DESIGN/PROCESS CHANGE NOTIFICATION -- FINAL

Change Type Description: Alternate Assembly/Test Location/Qualification

Description of Change (From): MOSFET products identified in the Affected FSID list assembled at Fairchild Semiconductor in Suzhou, China (FSSZ)

Description of Change (To): GEM Electronics Shanghai, China is now qualified to produce the MOSFET devices identified in the Affected FSID section on this PCN. GEM Electronics has been a qualified assembly and test manufacturer for Fairchild Semiconductor since 2001

D-pak Package visual comparison as below

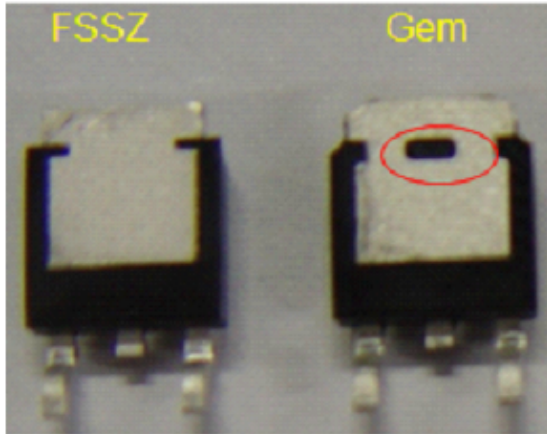
Note: there is a slot hole on GEM heat sink surface for both DPAK and IPAK compared with Fairchild Suzhou (FSSZ) product. There is no impact to the application
